PLANNING AND ZONING - LAND USE DEPARTMENT

ARCHITECTURAL REVIEW COMMITTEE

12. Eversource

Application PLPZ2015 00050 for Exterior Alteration review for the construction of a new substation on a property located at 290 RAILROAD AVENUE, GREENWICH in the GB zone. Proposed use: utility Existing use: retail (Pet Pantry)

Members of the Architectural Review Committee react to the rendering of Eversource's proposed substation Wednesday night in Town Hall Cone Room. Left to right: Cindy Tyminski, Louis Contadino, Ken Deck, Paul Pugliese, Heidi Smith, Mark Strazza and James Doyle. Credit: Leslie Yager

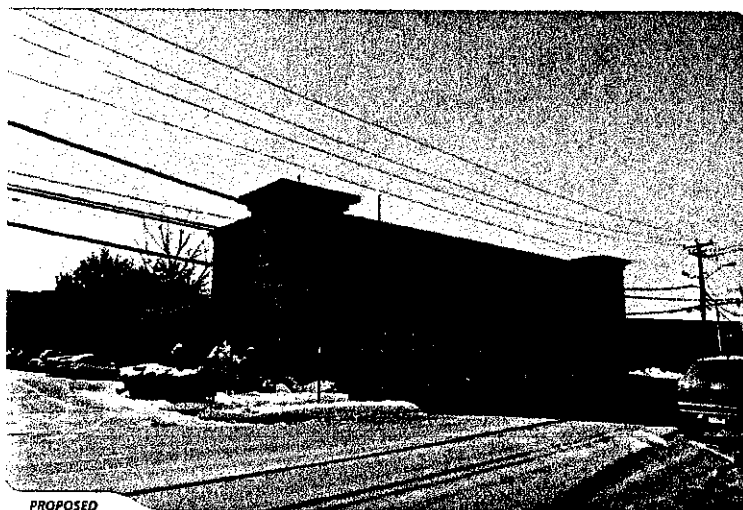
- Great improvement that the building was moved and lowered in height. The massing and way it sits on the site is also improved from what was previously presented.

- The architecture, as presented, is still not acceptable due to the following:
 - o Building does not have proportion and integrity that it should or could have.

- o It does not fit in with the character of the neighborhood.
 - o Better detailing and materials need to be reviewed.
 - o Too much framework (cement panel) compared to brick.

- o They should use real windows that are not transparent because it will allow for liveliness from the reflections.
 - o The front door is out of proportion and looks too residential.

- o Need actual architectural drawings and not just renderings.
- This intersection is an entrance to Downtown Greenwich and the elevation along Field Point needs to be addressed as well.

- There are 2 or 3 high quality, large caliper, fastigiate oaks on the property and they should be preserved. Need a landscape plan for entire site for ARC review.

- The accessory structures need to be clad in a similar material to the main structure.
- Wrought iron fences should relate to one another and be of similar size and scale.

Eversource's original rendering of proposed building, which measured 120 ft by 50 ft gray building, with a height of 35 ft. Credit: Leslie Yager

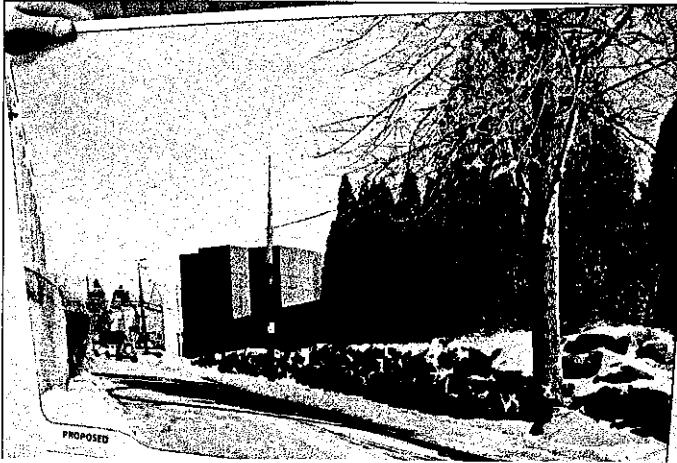
Back in early March, ARC blasted Eversource on the aesthetics of their rendering of the building that will replace the warehouse they sublet to Pet Pantry.

A member of the committee described the building was "an assault on the intersection."

"It looks like an abandoned hotel. And I'm being nice," Paul Pugliese said. He said the small residential-looking door at the front looked out of place.
